RIVERBEND WATER RESOURCES DISTRICT PUMP STATION & GROUND STORAGE TANKS PROJECT

ADDENDUM NO. 1

FROM: Stokes & Associates, Inc.
DATE: June 6, 2017
TO: All Plan holders

UNIT HEATER SCHEDULE

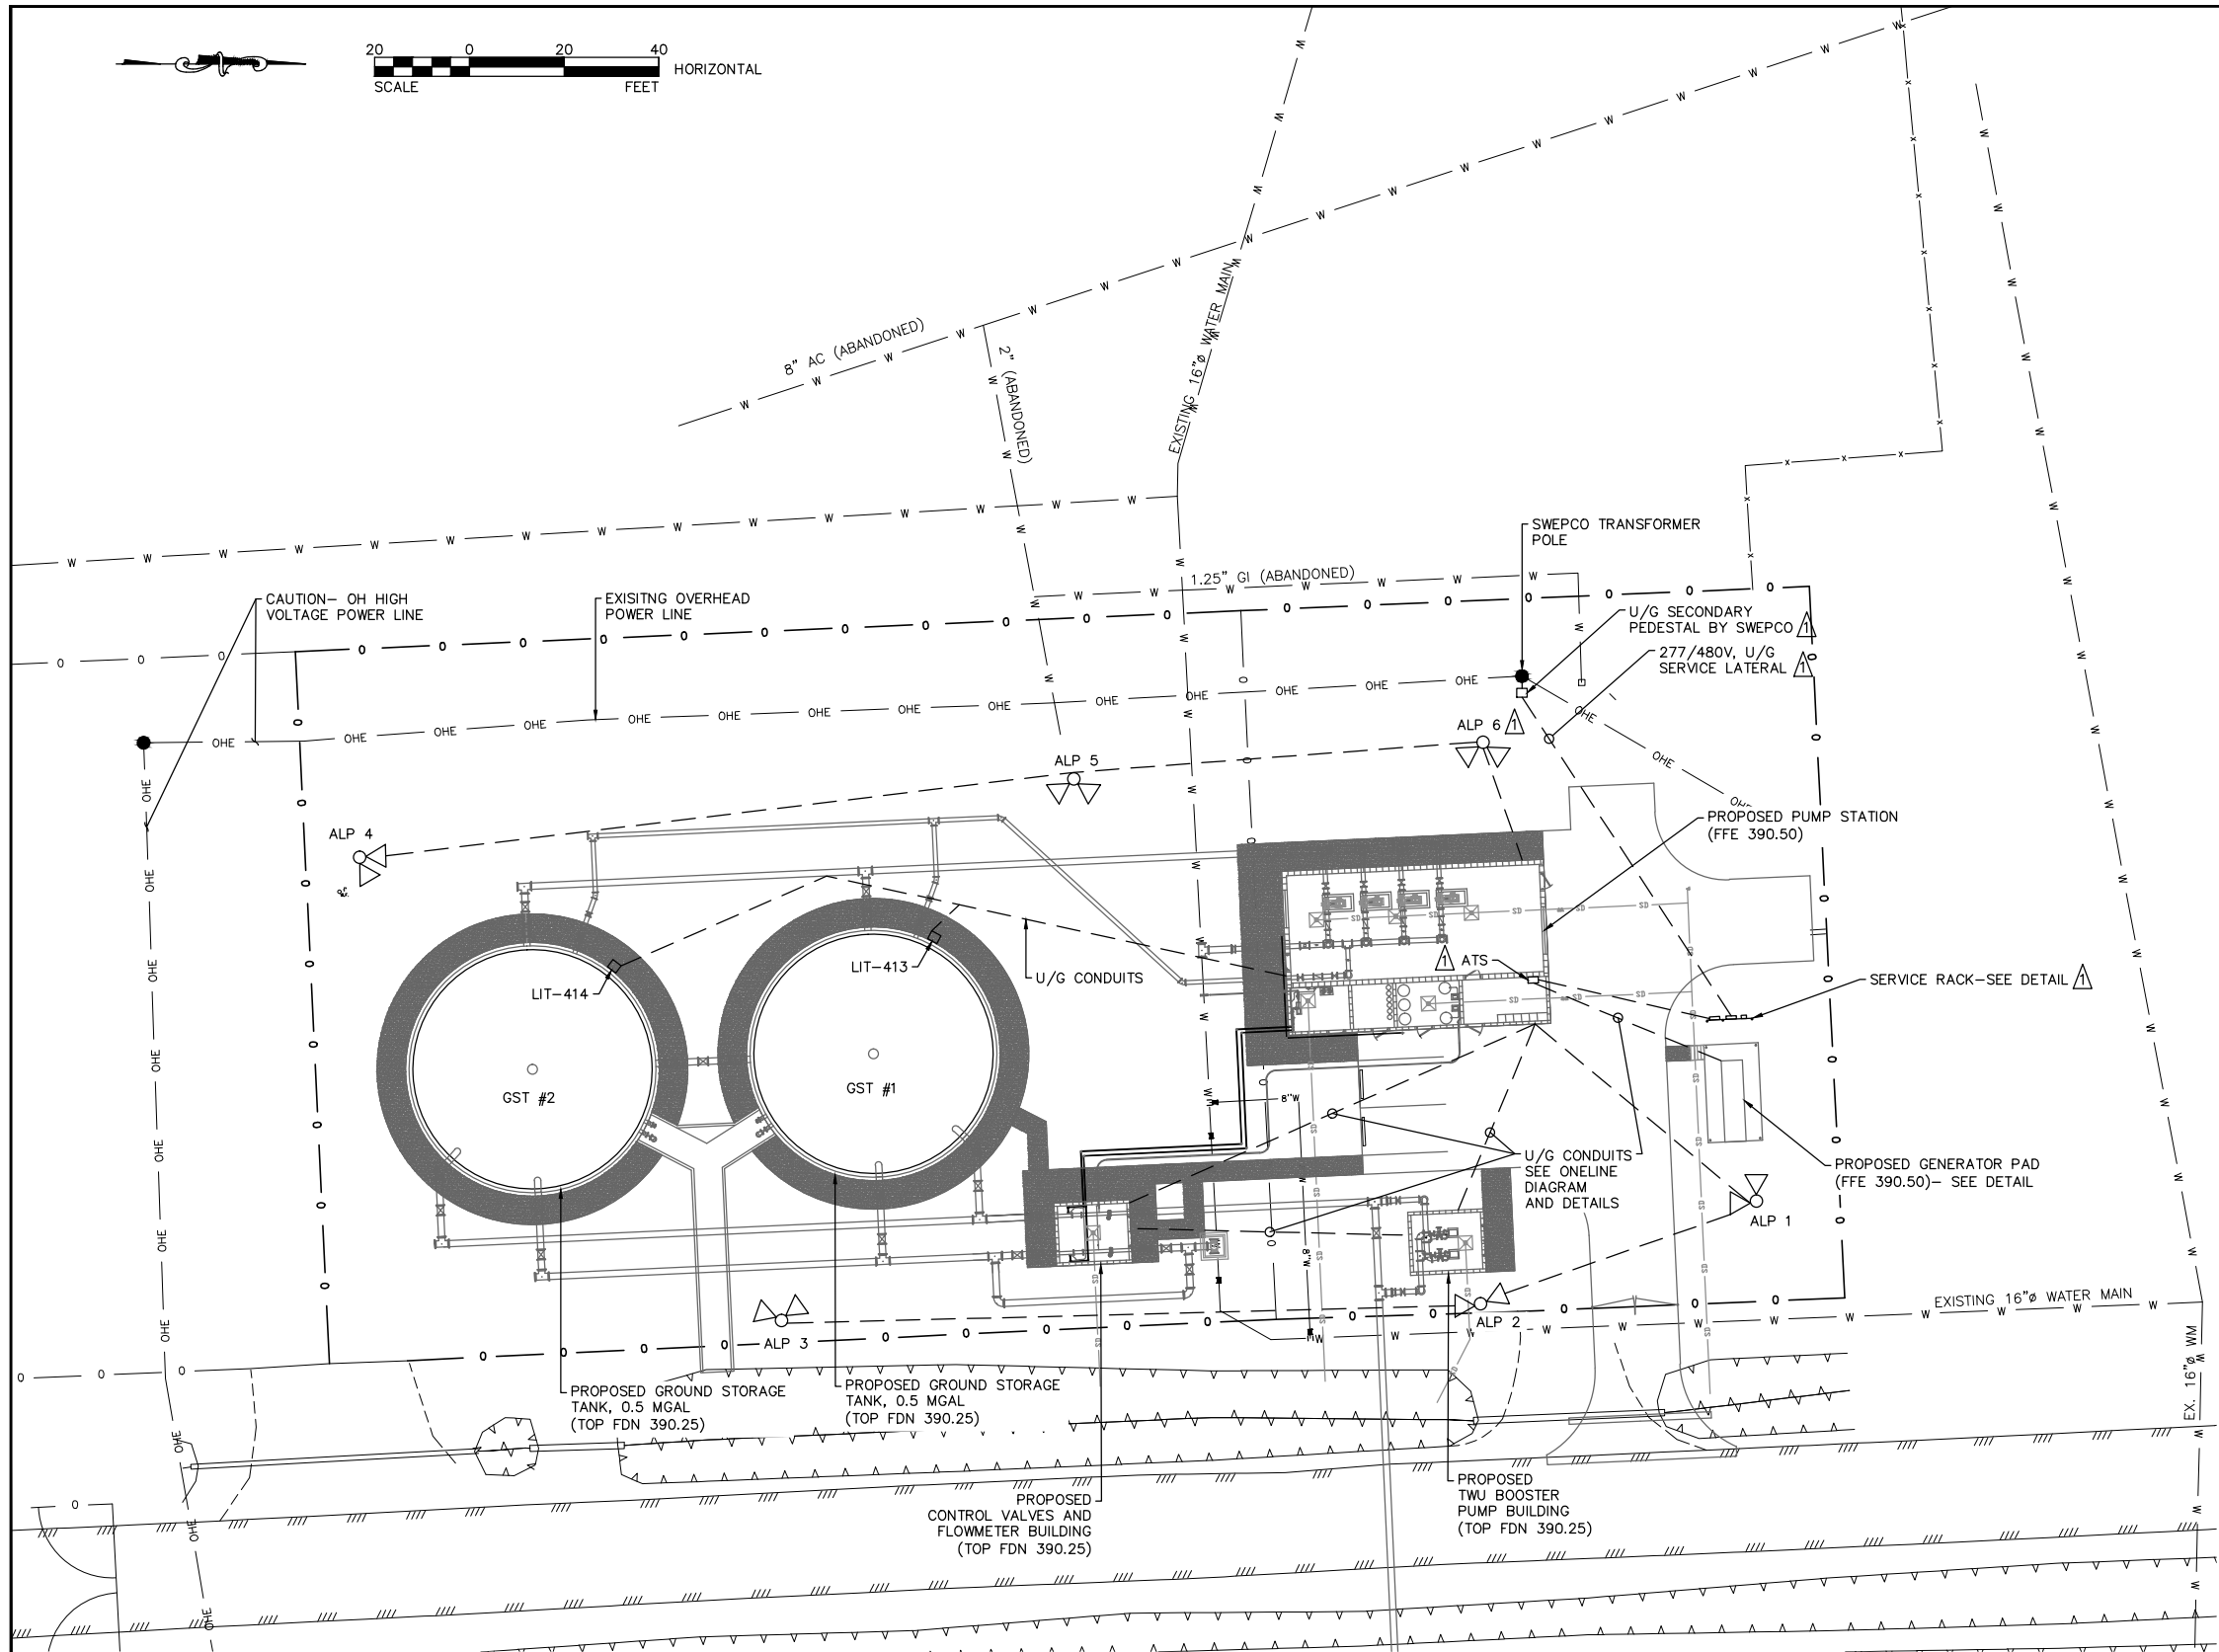
1. The standby diesel generator shall be rated 300KW/375KVA and is incorrectly shown on the Online Diagram on sheet E-3.
2. See attached "Unit Heater Schedule" for the heaters in the pump room.

UH1/UH2 10 KW, 480V, 3 ϕ , ELECTRIC, WASH-DOWN, UNIT HEATER,
 IDEECO TRIAD CATA.#234-U11N-0100U3 WITH UNIVERSAL
 MOUNTING BRACKET, & THERMOSTAT CATA.#1004328,
 OR EQUIVALENT BY Q-MARK.

SHEET IDENTIFICATION:
E-1

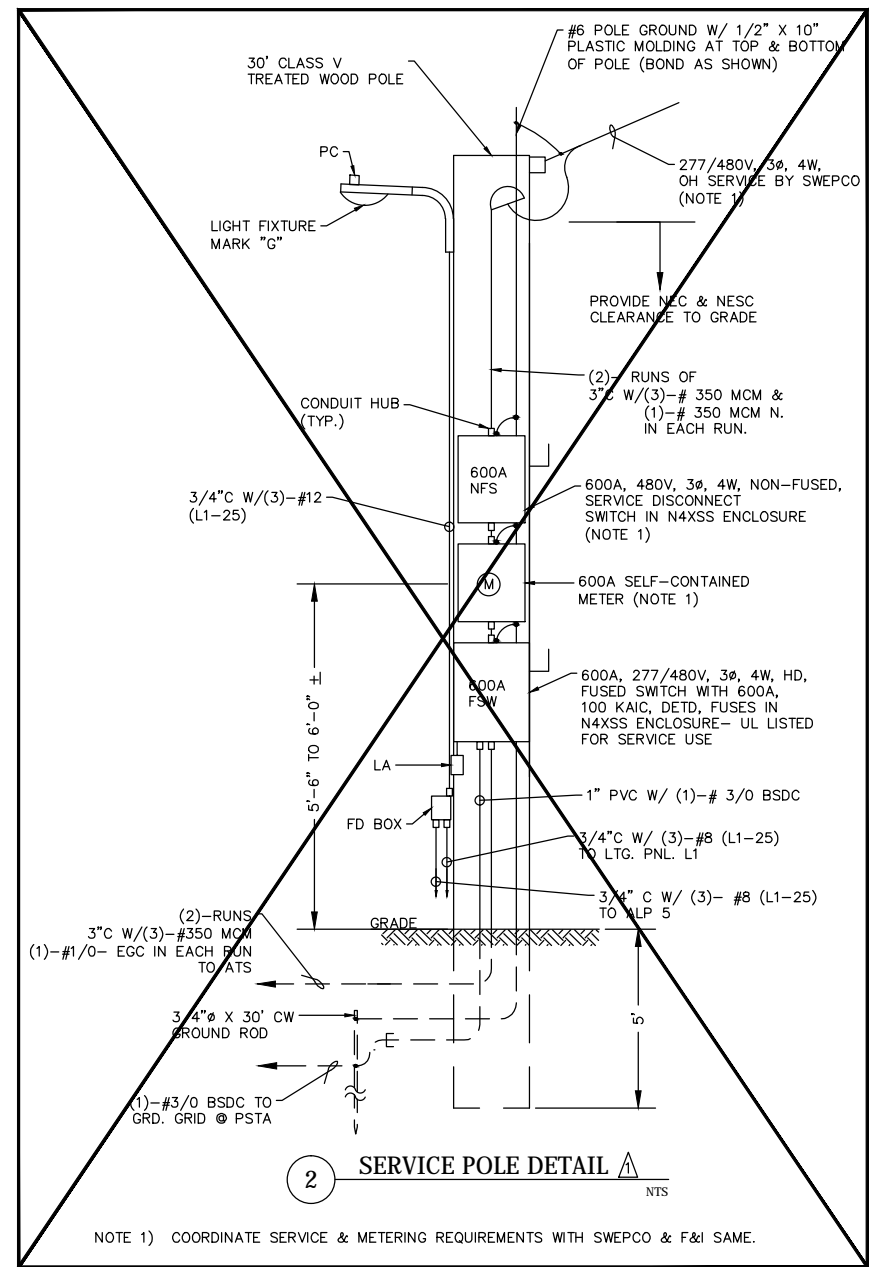
- The electrical plans have been revised to include a service rack for the meter, C.T. enclosure and a main fused switch. Revised Plan Sheets E-1, E-3 and E-9 are attached.

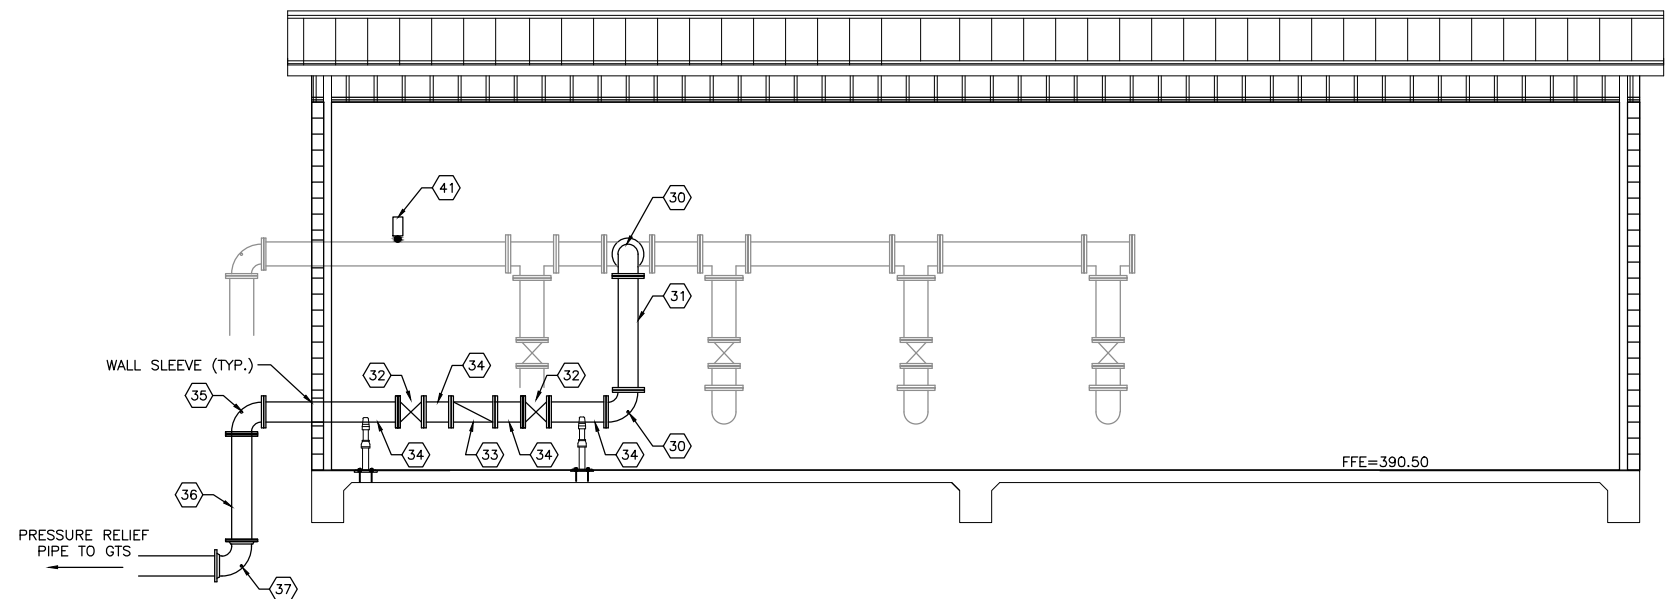
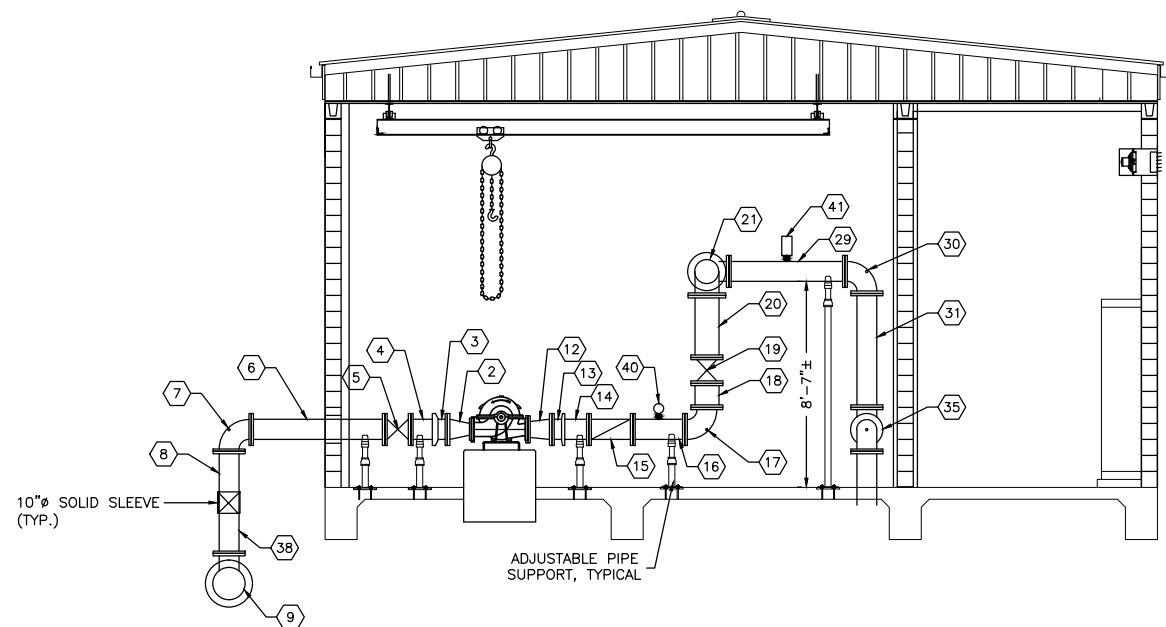
- Plan Sheet C-501 Detail 9 – Note #2 shall be revised; delete the sentence “For sawcut joints, discontinue reinforcing and place No. 3 dowels at a maximum of 60 feet. This should have referred to an Expansion Joint – see Detail 4 for Expansion Joint details. Sawcut Joints shall be per Detail 2.
- Plan Sheet M-107 has been revised – Section View #2 has been revised to clarify the absence of a lower pipe header. See attached Plan Sheet M-107.
